DELAWARE RIVER AND BAY AUTHORITY

WILMINGTON AIRPORT

ADDENDUM NO. 1

DEPARTURE LOUNGE CONCESSION AREA

C-A-571R1

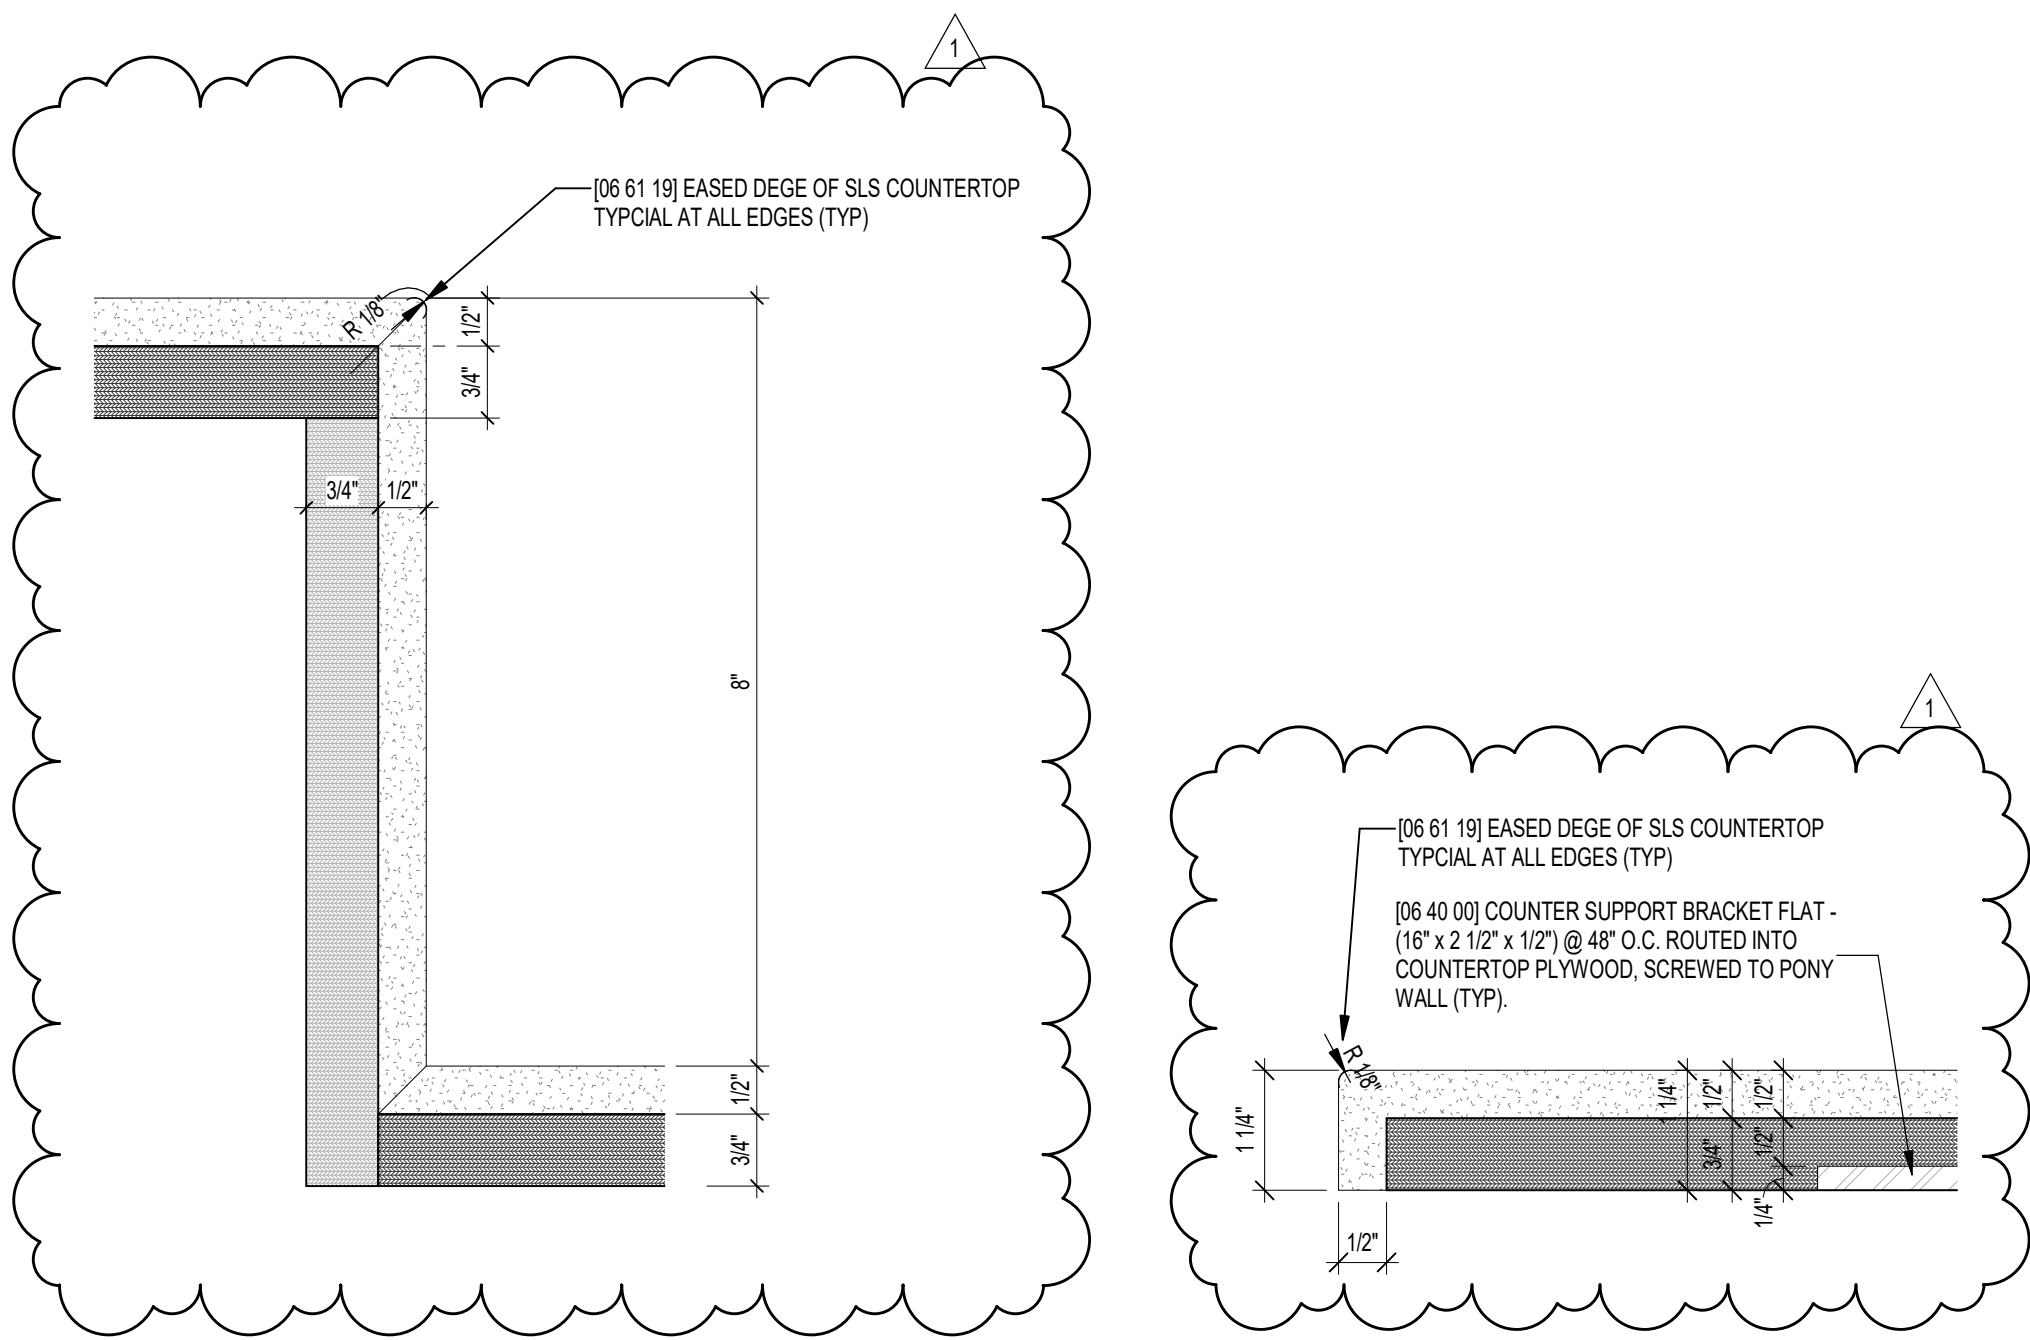
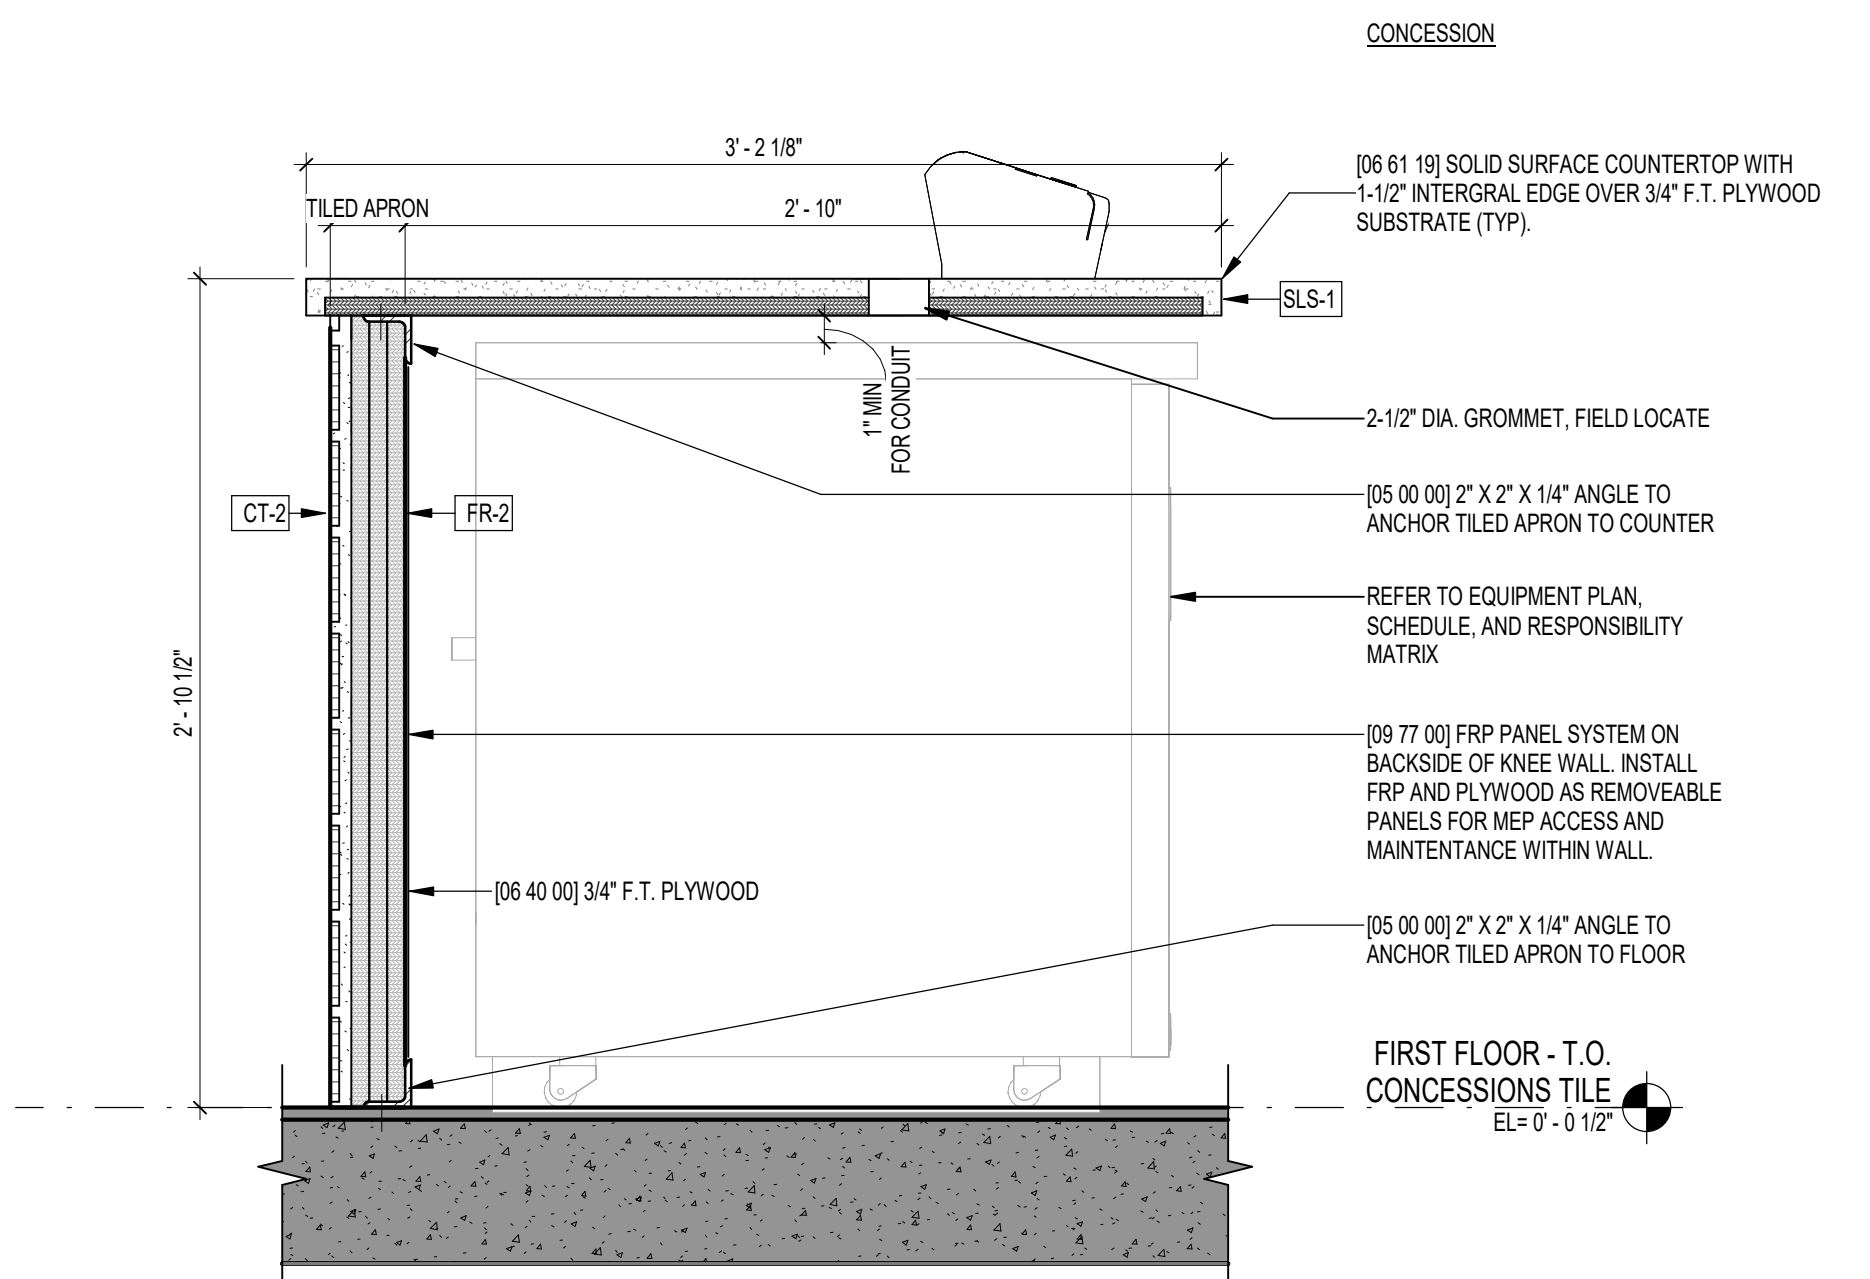
- Q6. Plan Sheet A-571 Finish Schedule calls for SLS-1 Dupont Corian Designer White. This is ½" thick. All sections on this sheet show material at ¾" in which would be Dupont Quartz Designer White. Do you want Corian or Quartz?

- A6. See Amendment No. 1. Corian; thickness dimensions on Plan Sheet A-571 have been updated.
- Q7. Plan Sheet A-100 has reference tag as #5 but there is not an elevation 5 on any of the plan sheets. We need the elevation 5 to see what you want for millwork under the countertop. Designer White is only available as a solid surface color. DuPont only offers ¾" thick solid surface in glacier white and cameo white, which is non-stock / special order / available in pallet quantities of 7 sheets. The sheet size is ¾" x 30" x 144". Otherwise, Designer White is available in ¼" x 30" x 98" sheet size, but this material is also non-stock / special order / available in pallet quantities of 16 sheets.
